A d d e n d u m

Iowa Department of Transportation
Office of Contracts

B.O.	Proposal ID	Proposal Work Type	County	Project Number	Addendum
001	07-0636-075	BRIDGE NEW - PPCB	Black Hawk	NHSX-063-6(75)--3H-07 NHSX-063-6(87)--3H-07 NHSX-063-6(90)--3H-07 NHSX-063-6(92)--3H-07 NHSN-063-6(94)--2R-07 NHSX-063-6(96)--3H-07 NHSN-063-6(97)--2R-07	20JUN001A04

PLAN: NHSX-063-6(90)--3H-07

BORING LOCATION PLAN AND PROFILE

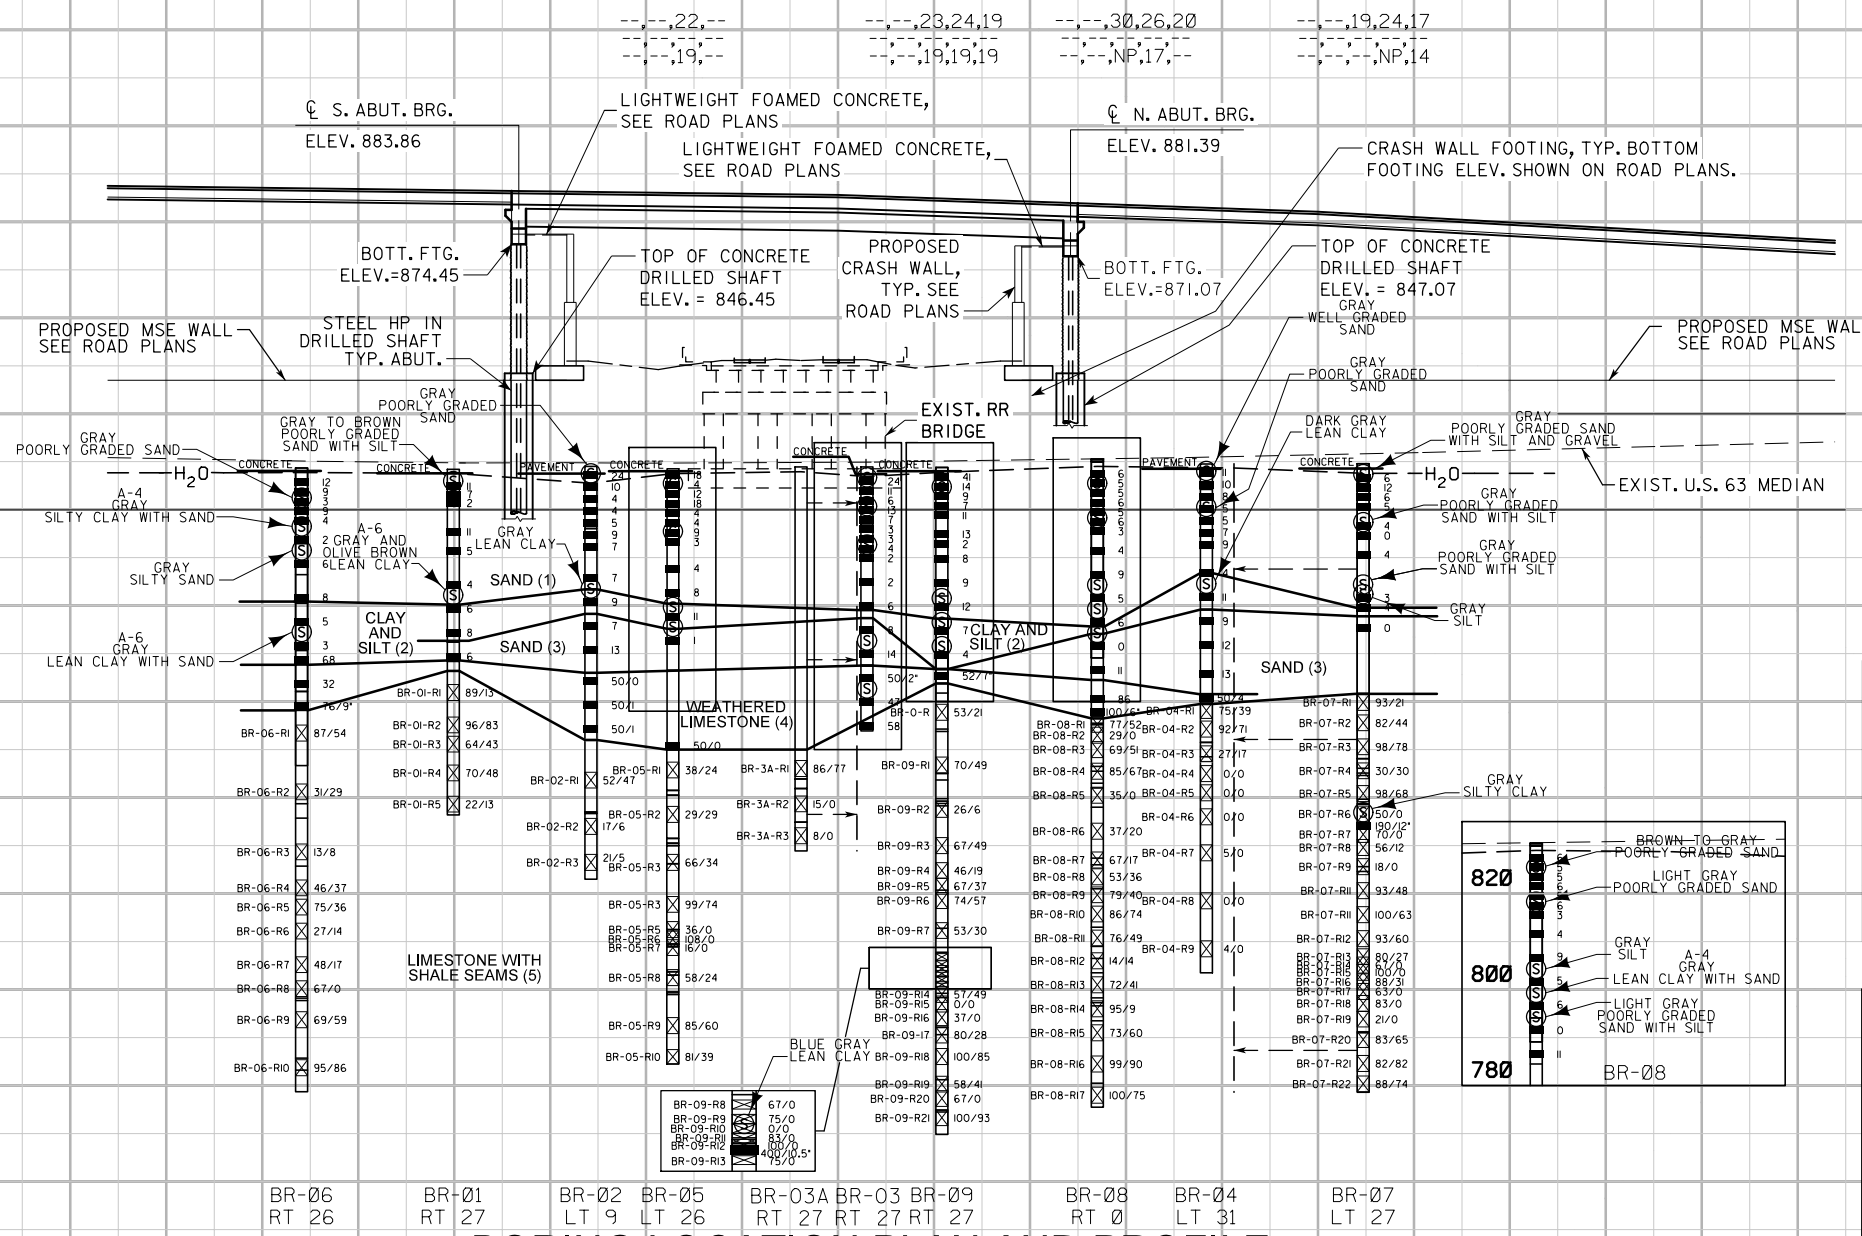
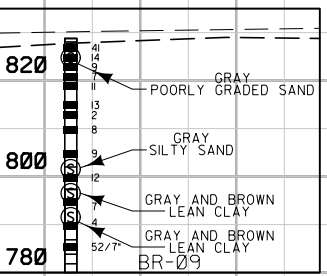
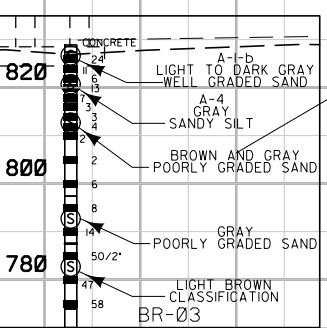
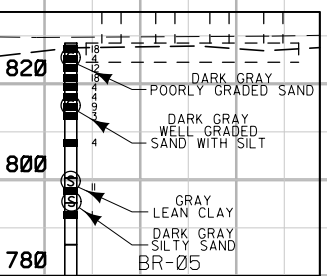
Replace SHEET NUMBER SPS.1 with the attached SHEET NUMBER SPS.1:

"Acceptable areas for demonstration pile installation are shown as **red shaded areas** in the attached plan. The Contractor shall install the demonstration pile such that it is not in conflict with the existing underground utilities/structures and any proposed construction elements"
